**Compliance with Approval Condition (e)**

**Temporary Shop and Services and associated Filling and Excavation of Land for a Period of 3 Years in “Other Specified Uses” annotated “Service Stations” Zone at Lots 733SF(Part), 737RP(Part), 738RP, 741(Part), 742RP(Part), 744RP(Part) and Adjoining Government Land in DD99, San Tin, Yuen Long, New Territories**

(Application No. A/YL-ST/600)

**Drainage Proposal in compliance with  
Planning Application No. A/YL-ST/600 Approval Condition (e)  
for Proposed Temporary Shop and Services and associated Filling  
and Excavation of Land for a Period of 3 Years in “Other  
Specified Uses” annotated “Service Stations” Zone,  
Lots 733 SF (Part), 737 RP (Part), 738 RP (Part), 741 (Part),  
742 RP (Part) and 744 RP (Part) in DD99 and Adjoining  
Government Land, San Tin, Yuen Long, New Territories**

何田顧問工程師有限公司 <b>HO TIN &amp; ASSOCIATES</b> CONSULTING ENGINEERS LIMITED	
SCALE 1 : 2500 - A4	DRAWING No. FIGURE 2

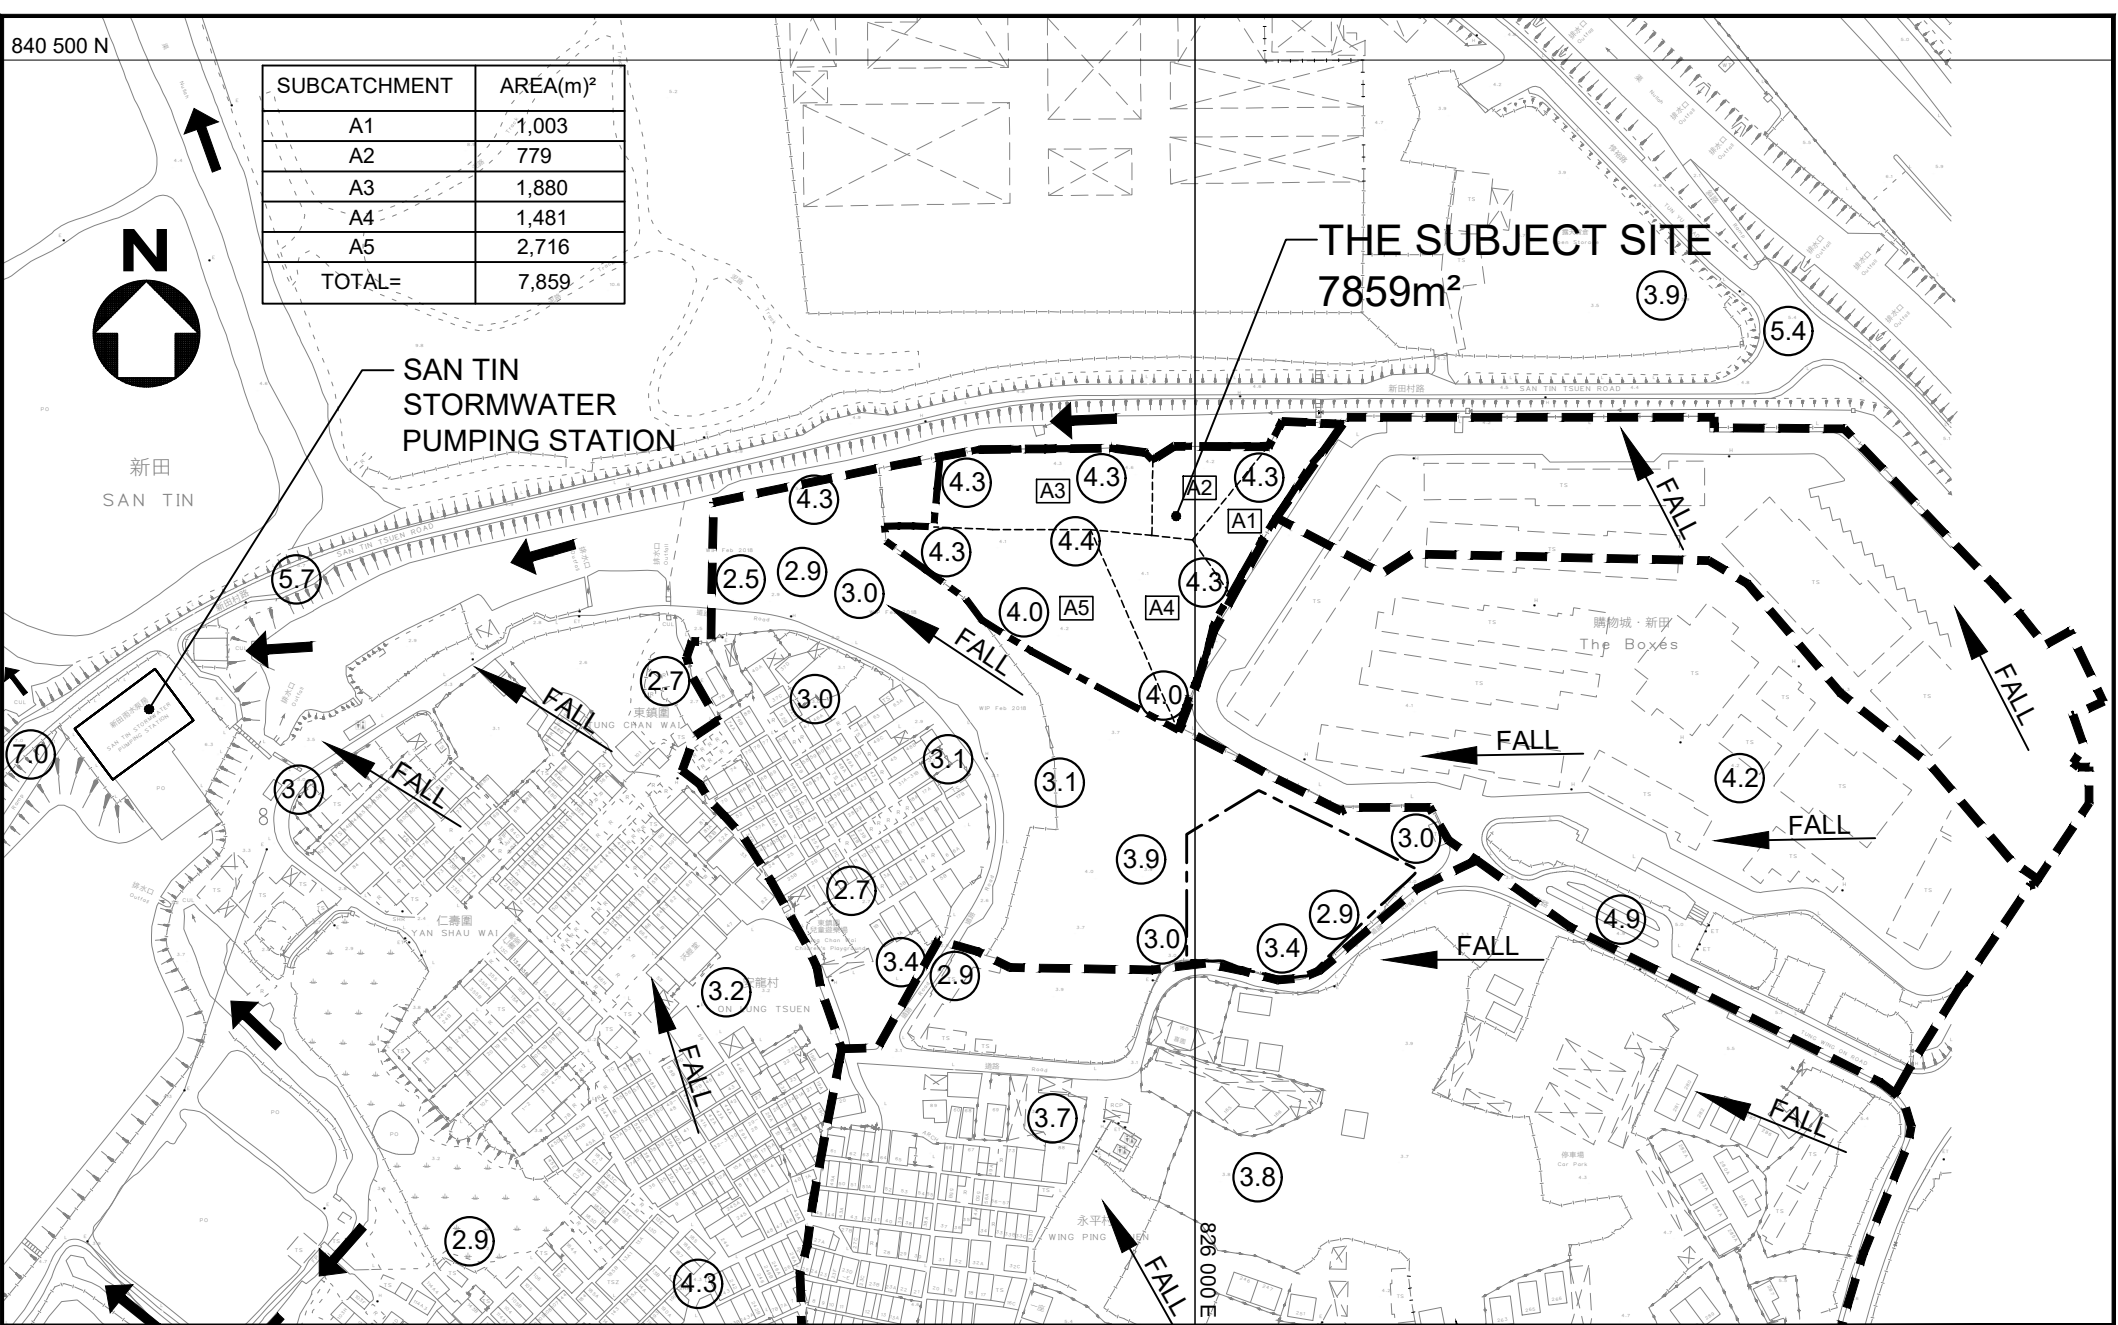
<p>(iii) Section 5.1.1 refers. The changes in paving condition, the drainage flow path and drainage impact to the adjacent areas before and after the proposed development should be presented;</p>	<p>There is no change in paving condition, the drainage flow path and drainage impact to the adjacent areas before and after the proposed development. A corresponding statement is added into Section 5.1.1.</p>

DRAWING NO.  
HT 21094 / DD / 01

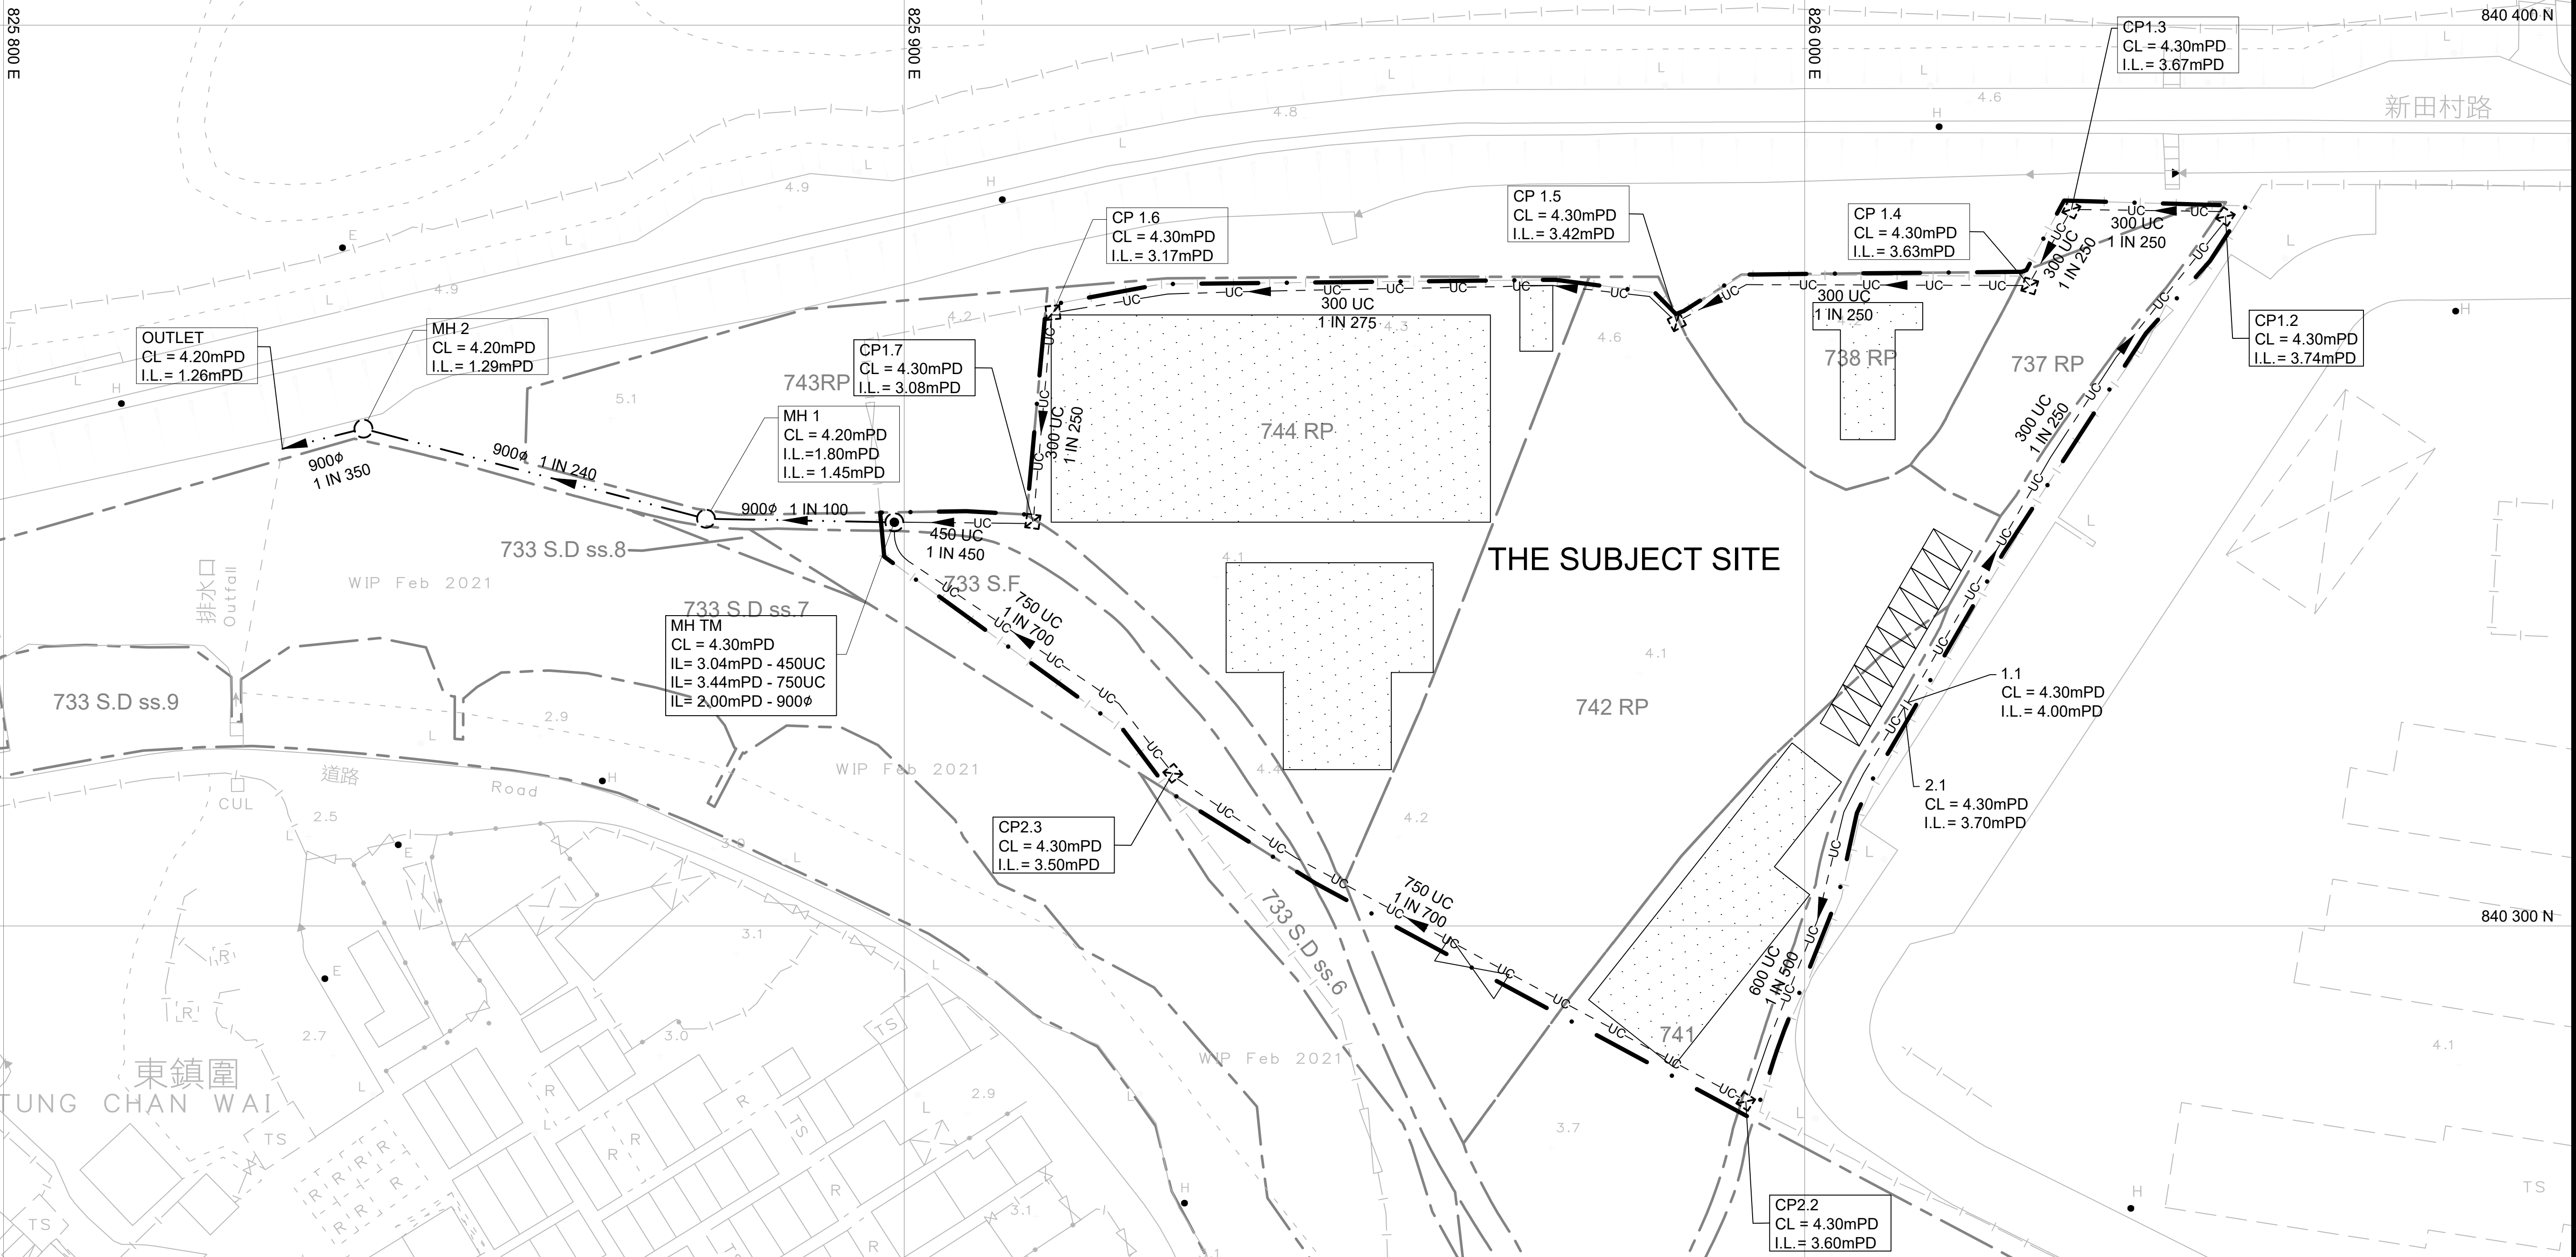
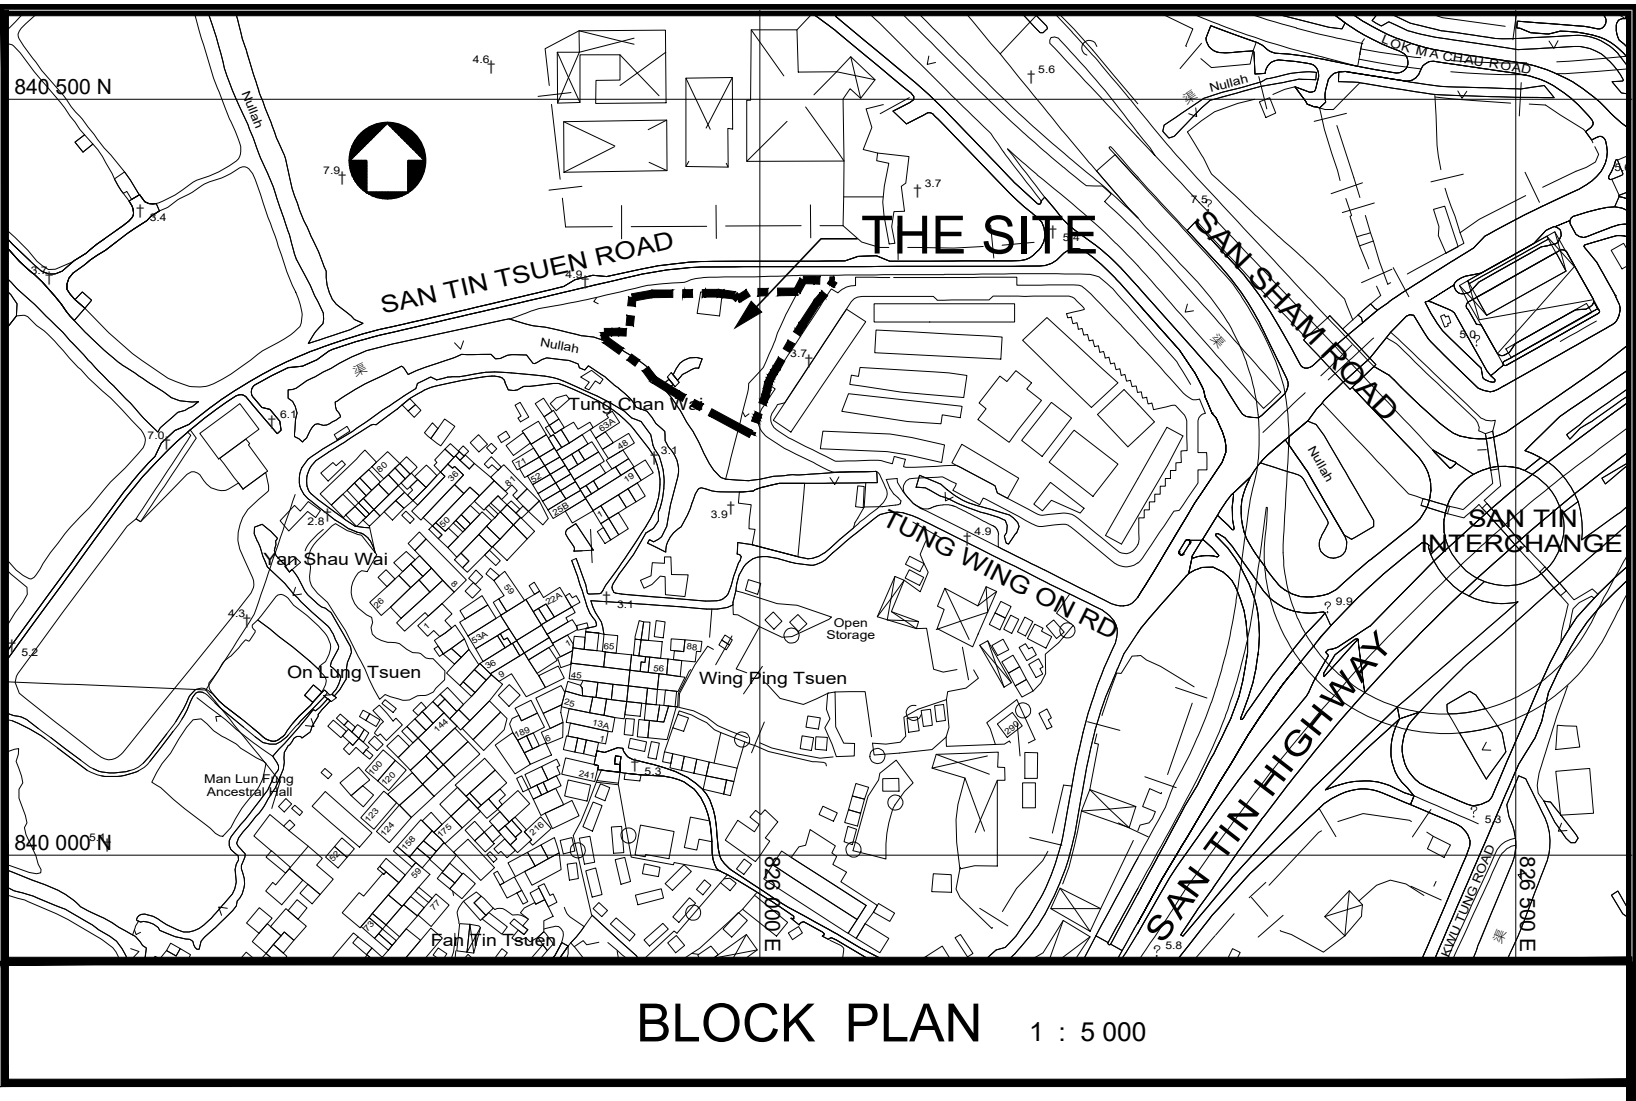
(v) Section 6.4 and Appendix refer. The drainage calculation for the 50-year rainfall event is missing in the Appendix;	Drainage calculation for the 50-year rainfall event is added in the Appendix in this resubmission.
(vi) Drawing No. HT21094/DD/01 refers. As no internal drains are provided within the Site, please demonstrate how the catchment areas for the peripheral drains are determined;	The ground levels of the subject site slope downward from the centre toward the subject site boundary. The catchment areas for the peripheral channels are determined according to the apportionment of the sloping grounds with respect to each channel. In order to cater for the effect of existence of buildings encroaching upon more than one catchment, the concerned catchments are summed up and conservatively adopted as the catchment of the corresponding channels at the most upstream. Calculations in the Appendix are amended accordingly.
